REMARKS

Serial No: 09/803,103

FIG.5

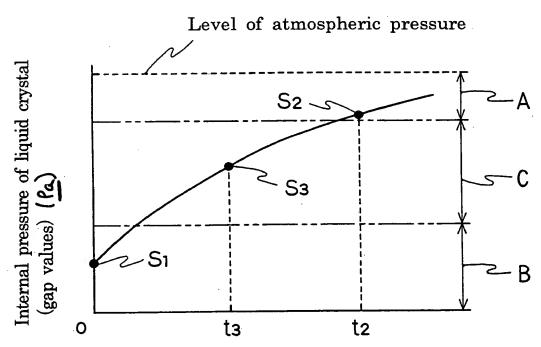
The Examiner has objected to Figure 5 for not containing units of time and pressure. Applicants respectfully submit herewith a proposed correction to Figure 5 indicating in red the appropriate units of time and pressure. Accordingly, withdrawal of this ground of objection is respectfully requested.
